**From:** [Craske, Alice](#)  
**To:** [A47 NorthTuddenham to Easton](#)  
**Cc:** [Cumming, David](#); [Faulkner, Stephen](#); [Allfrey, David](#)  
**Subject:** NCC North Tuddenham to Easton - Written Representation  
**Date:** 01 September 2021 15:35:05  
**Attachments:** [image012.png](#)  
[image013.png](#)  
[image014.png](#)  
[NCC Summary, A47 North Tuddenham to Easton.pdf](#)  
[NCC North Tuddenham to Easton Written Representation.pdf](#)

# Report to Planning and Highway Delegations Committee

- 1.1. This report sets out Norfolk County Council's position with regard to the submitted Development Consent Order (DCO) application made under section 56 of the Planning Act (2008).

Appendix B: Wood Lane Junction showing connection to Norwich Western Link (in pink)

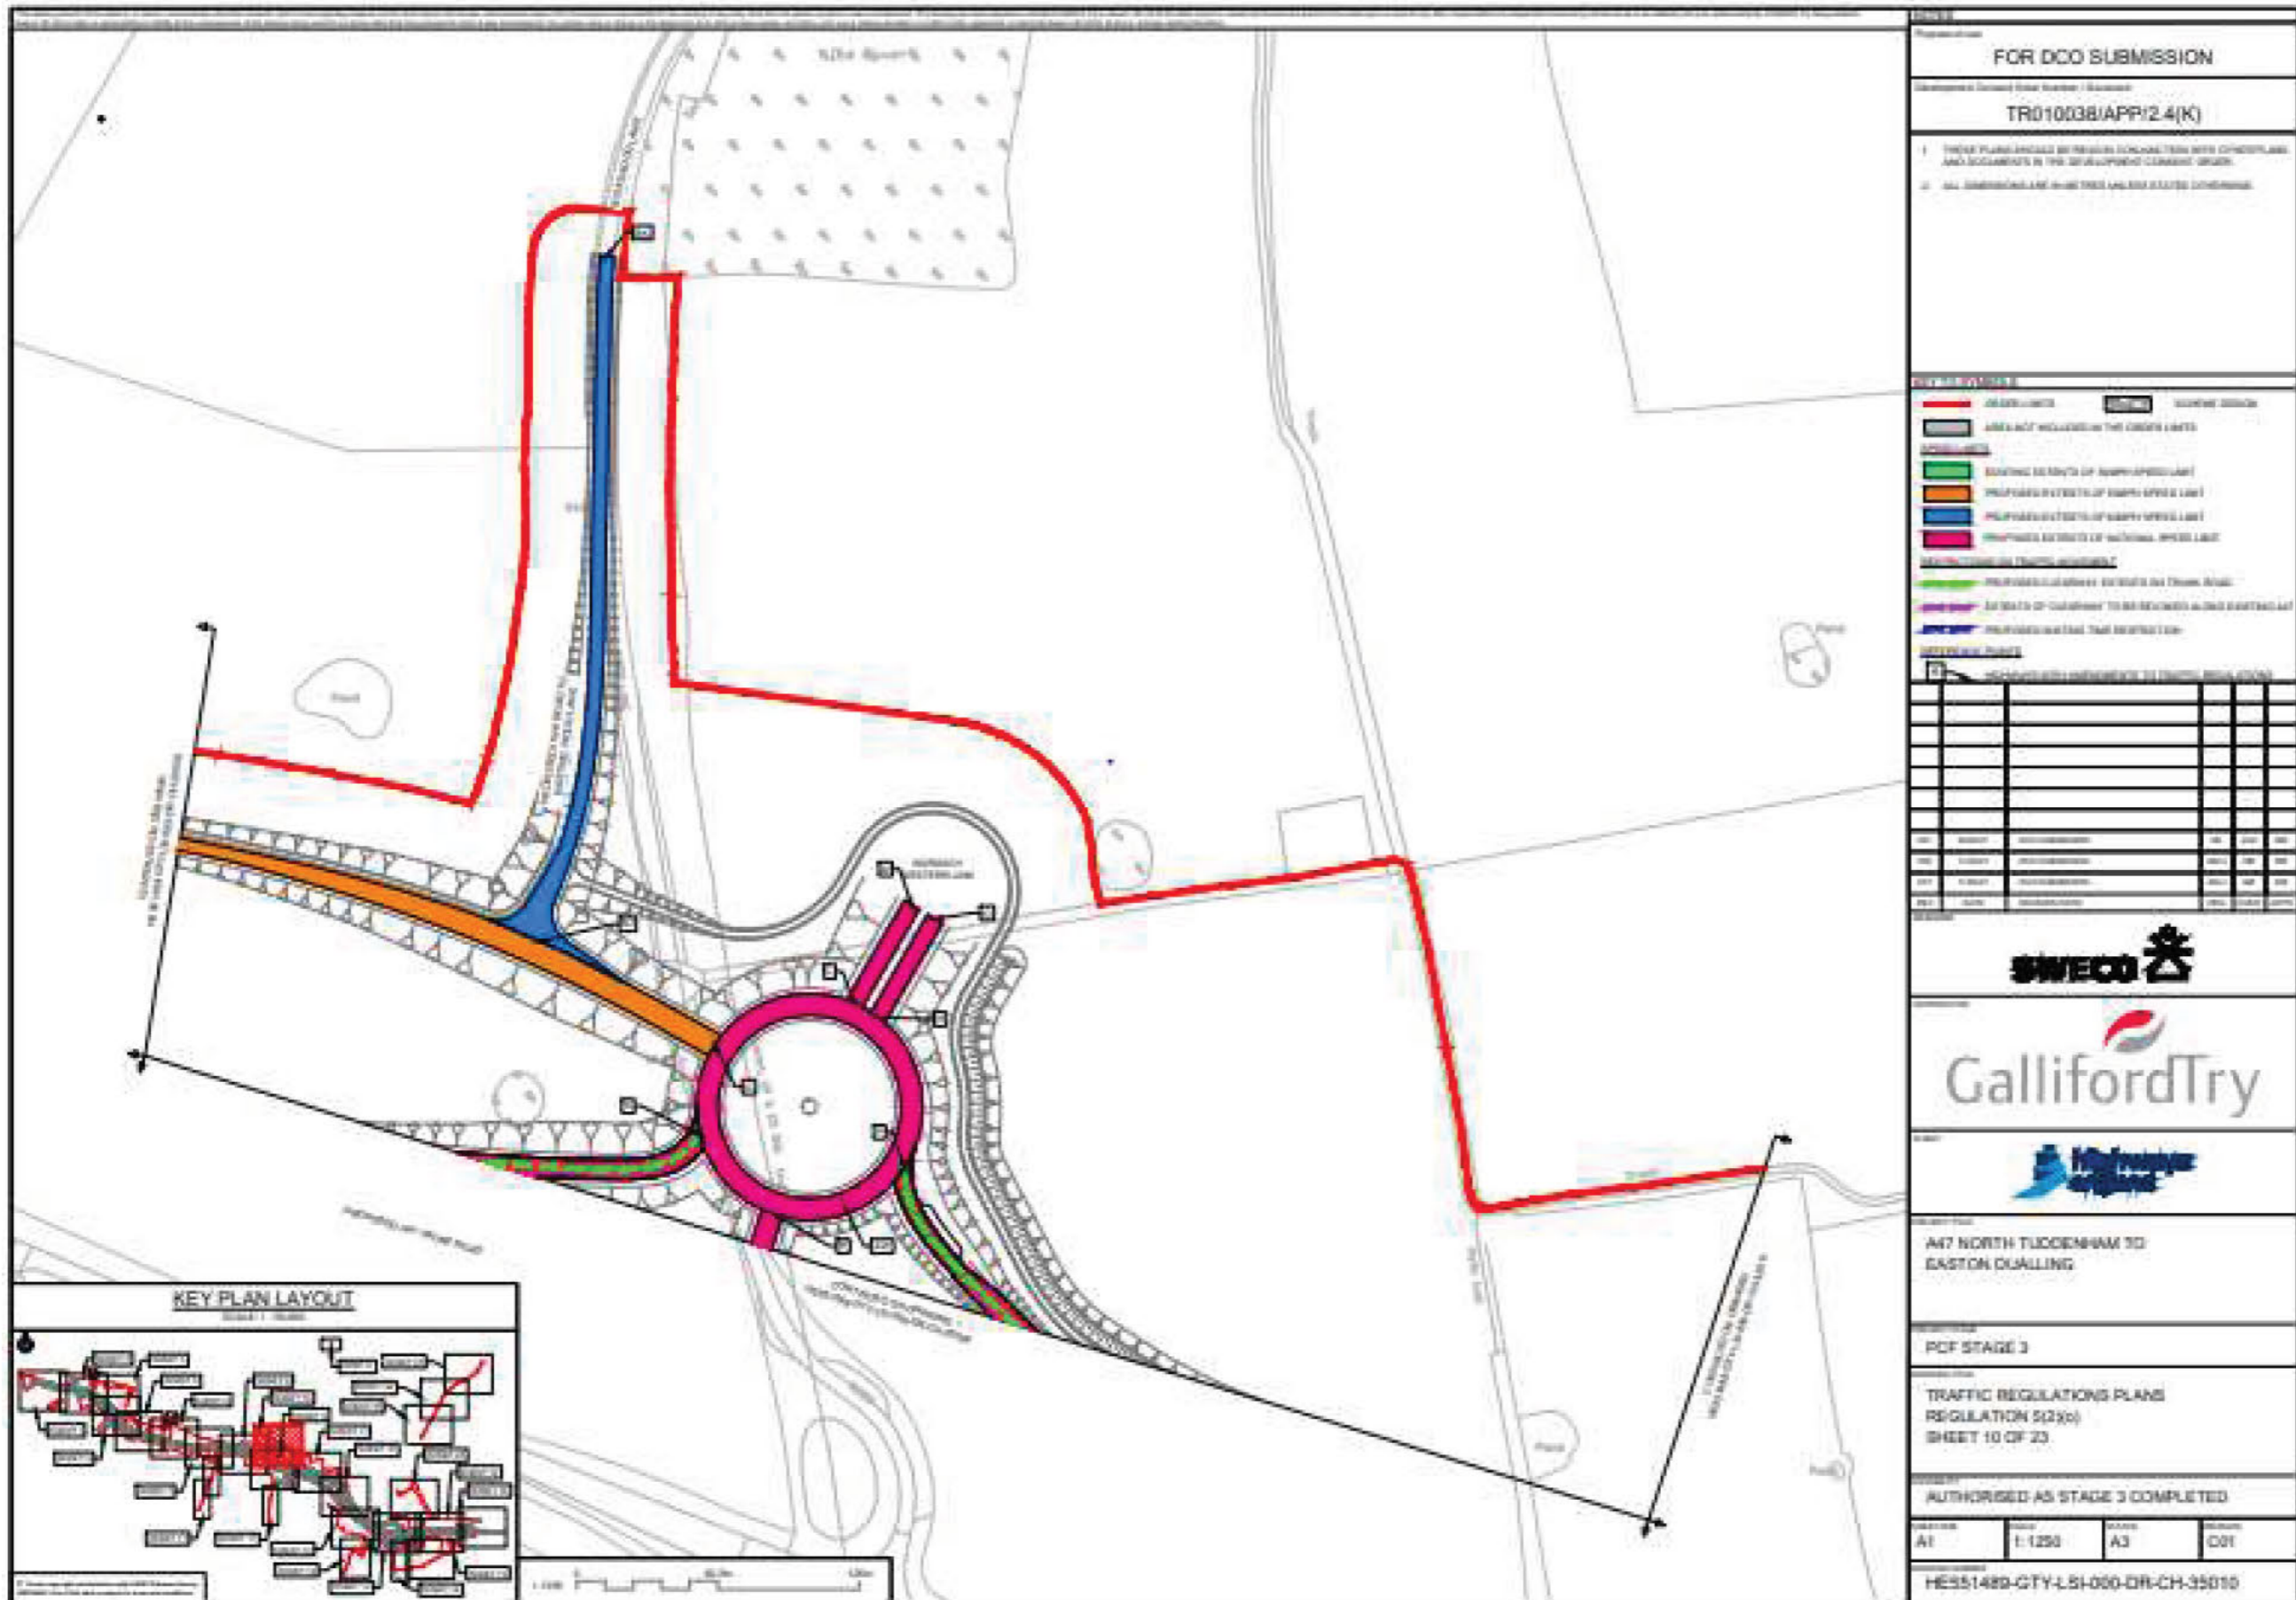
The A47 scheme includes a proposed cycle track between the realigned Wood Lane and Hall Farm Underpass. This is shown as looping round the NWL arm of the Wood Lane junction. In discussions with Highways England, Norfolk County Council understands that this is a temporary arrangement and, on completion of the NWL, will be superseded by the permanent facilities being planned as part of the NWL scheme.

However, we have concern that local users will not appreciate the temporary nature of Highways England's proposals in this area and would expect Norfolk County Council to provide a crossing of the NWL at the proposed A47 Wood Lane junction. This is not supported by the county council.

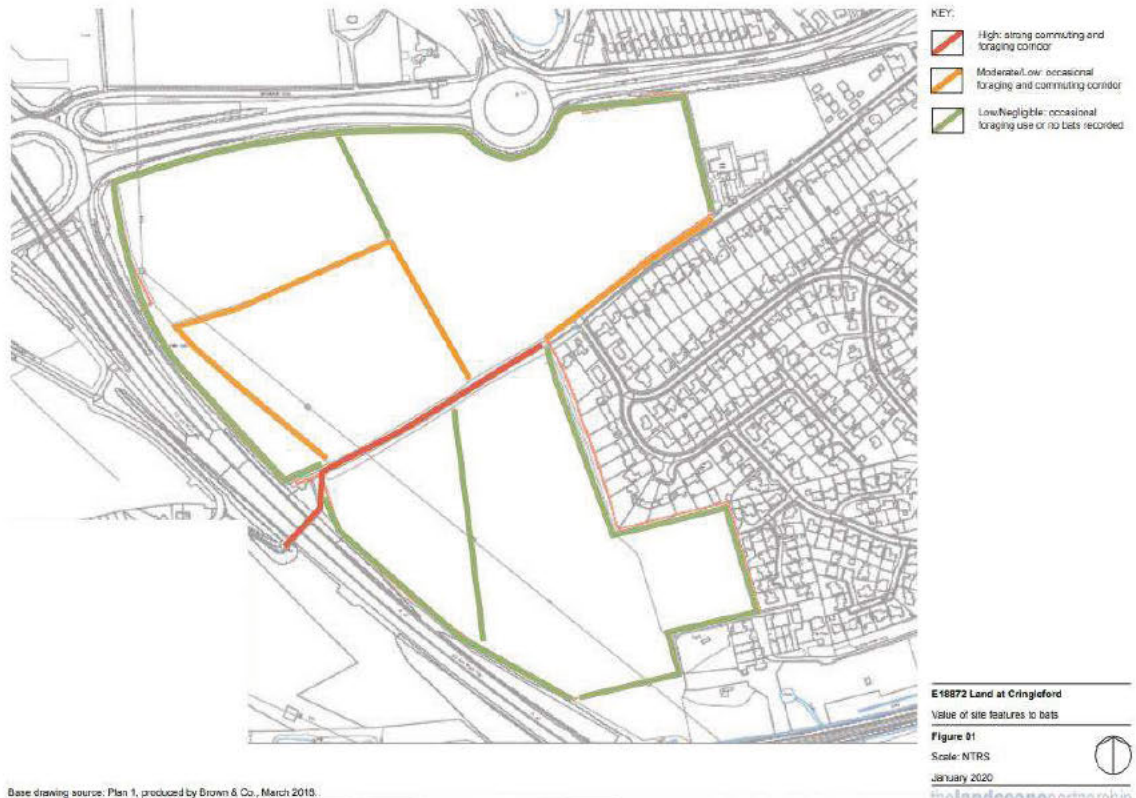
- Para 8.7.5 does not elaborate on how areas of 'high' bat activity was quantified.
- Table 8-9. (page 42) great crested newt. Notes that attenuation ponds are proposed as enhancement for great crested newts but it is not clear whether they will contain standing water, and for how long. Also, Table 8-12 (page 56) notes that the attenuation ponds are designed to reduce pollution entering nearby water courses, and as such would not provide suitable enhancement for great crested newts. There is no mention of enhancement of SuDS/attenuation ponds for great crested newt this in the Record of Environmental Actions and Commitments (REAC) in the Environmental Management Plan.

- Table 8-9 notes the translocation of 5m of important hedgerow but does not explain where this will be translocated to.
- Table 8-9 (page 39) notes that a UKPN cable is being installed within the CWS. It is not clear which CWS is referred to and this has not been previously mentioned in Chapter 8 or Chapter 15 – Cumulative Effects Assessment. Note: it is mentioned in B11 Table 3-1: Record of environmental actions and commitments

Environmental Statement - Appendix 8.1 Botanical Survey Report.pdf:

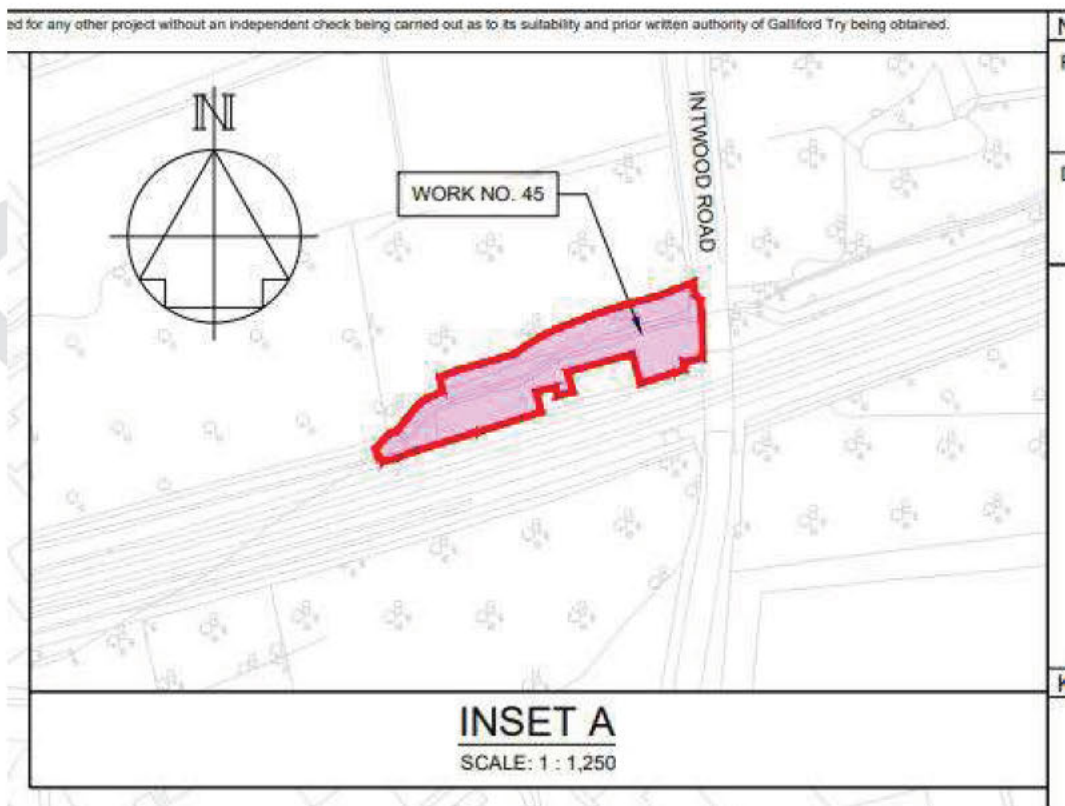
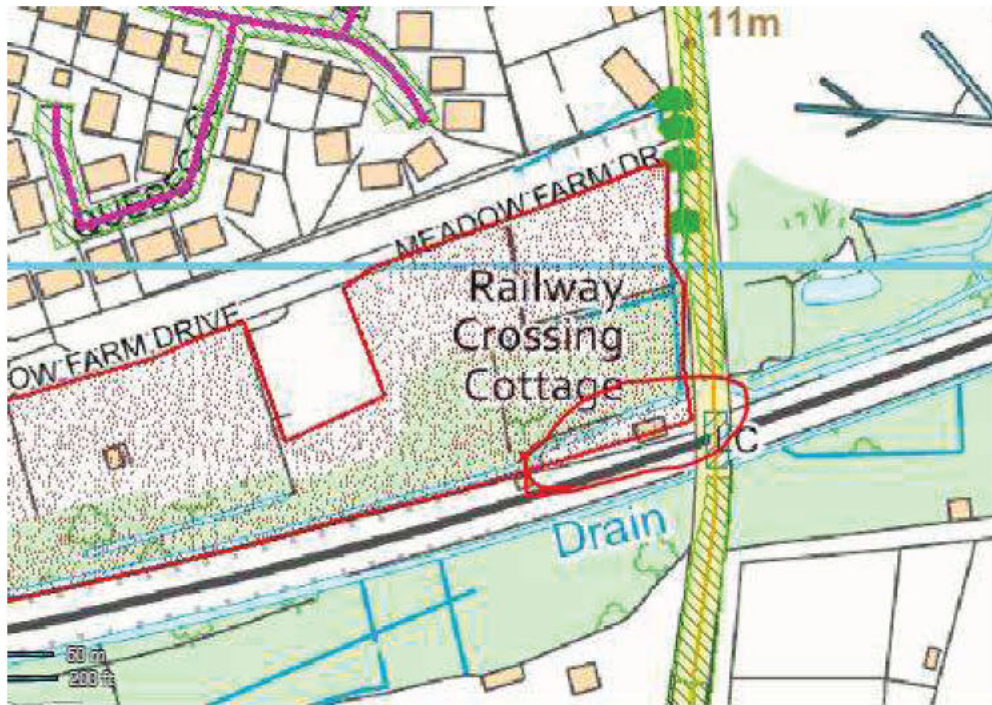
- The survey area (see figure 1a, page 9) differs from the current DCO red-line site boundary (see General Arrangements Plan).
- It is noted that Areas 'G' and 'I' are of district value, as is Meadow Farm county wildlife site (CWS).

- Hedgerows H2, H3, and H6 likely to be of ecological importance under the Hedgerow Regulations 1997 although it is not clear which hedges these refer to, or which hedges were surveyed as no plan showing, for example, H1, H2, H3... etc. has been provided. The Volume 2 2.12 Hedgerow Plans document does not use the same system (H1...H2) to identify hedges.

Figure 2b

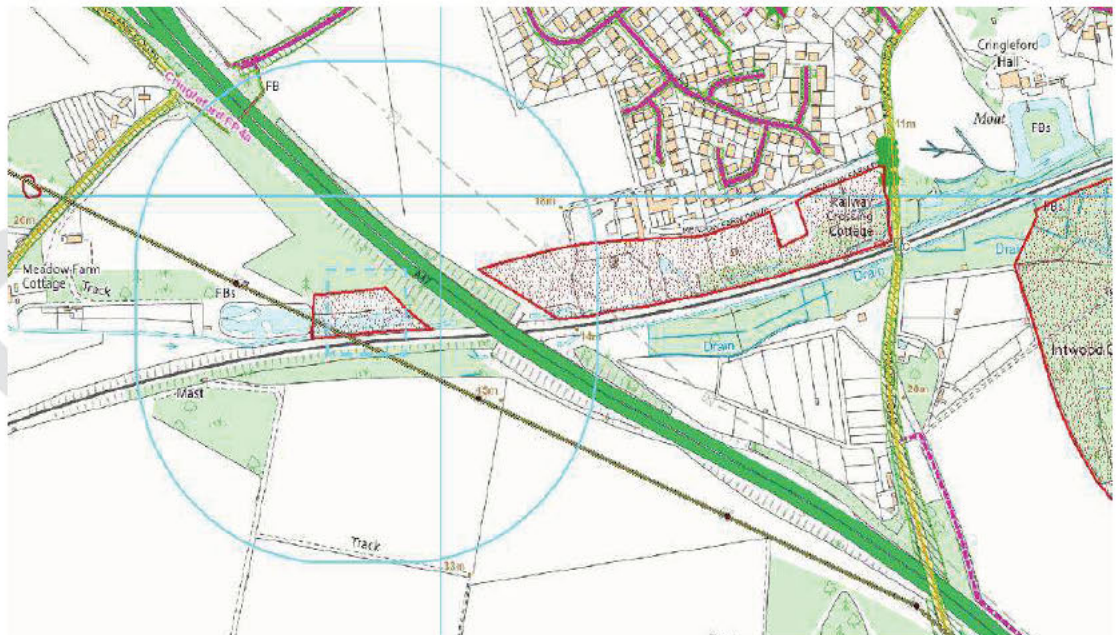
- Work Nos. 6 and 40 may also impact Meadow Farm CWS. Work No 49 abuts Meadow Farm CWS. Work No. 42 directly impacts Meadow Farm CWS and is associated within utilities diversion – it is not clear if this is associated with the UKPN cable route.
- Meadow Farm CWS is only shown to the right of the A47 (top, below). However, it extends to the left of the A47 as shown (bottom, below). This will affect the impact assessment and mitigation requirements.

- Para 7.6 also notes 'The southern edge of Area N, a priority habitat and potentially ancient woodland (present since at least 1840) will be impacted by a new road. This will be an intermediate impact on this feature. Mitigation is advised' the potential presence of ancient woodland is not mentioned elsewhere and Chapter 8 only refers to veteran trees on the ancient woodland inventory (para 8.7.14)
- It should be established if this woodland is ancient and the scheme re-designed to avoid this area as recommended in section 8 of the botanical

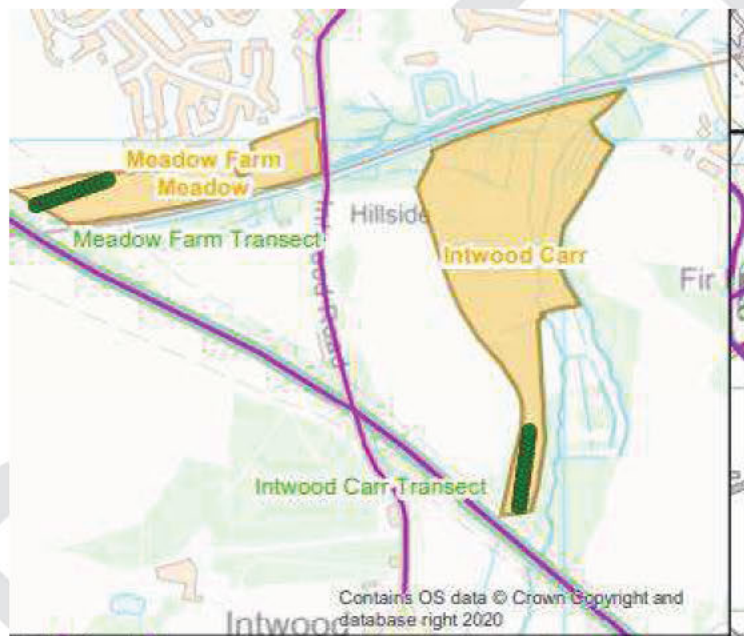
- Para 3.4.8 (below) - It is not clear why reference has been made to Bechstein bats as this species is not present in Norfolk. We (the Natural

Environment Team) were consulted in January 2021 with regards to the Long List. During this consultation we queried the use of a 2km CEA ZOI, suggesting the Core Sustenance Zones of bats is used. No mention was made to Bechstein bats.
